## Engineering Change Notification

This notice is to inform you of a change to the following LCD products:

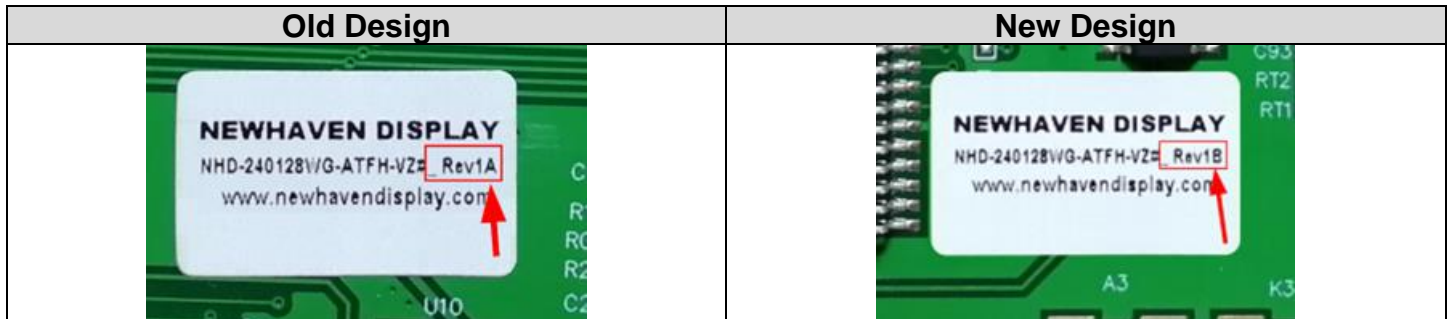
The RA6963-N controller IC used in these displays has been discontinued and replaced by RA6963-N1, which is an alternative version of the same controller.

The new version will be labeled with a different revision control number after the part number. See example below. The same revision control number may not apply for all models.
